Docket Item # 2  
BAR CASE # 2009-0058

BAR Meeting  
November 18, 2009

**ISSUE:** Demolition/Encapsulation

**LOCATION:** 702 North Patrick Street

**Figure 3: Photo showing Rear Elevation of 702 North Patrick from Alley**

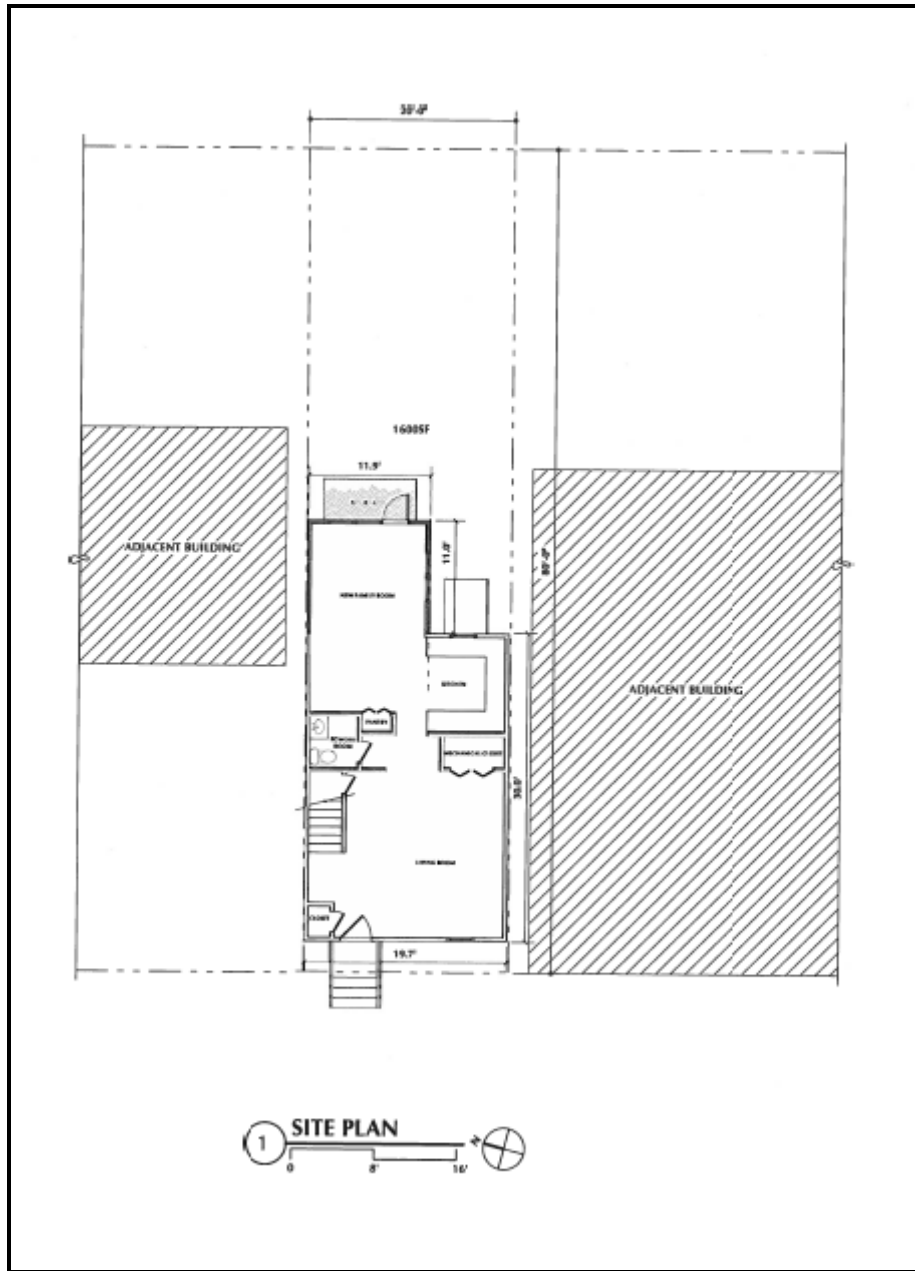
Views of the rear of the house where the demolition is proposed are limited to those visible from the 22 foot emergency vehicle easement. The easement is accessed from Wythe Street and provides access to the properties on North Patrick Street. The affected area is not visible from North Patrick Street.
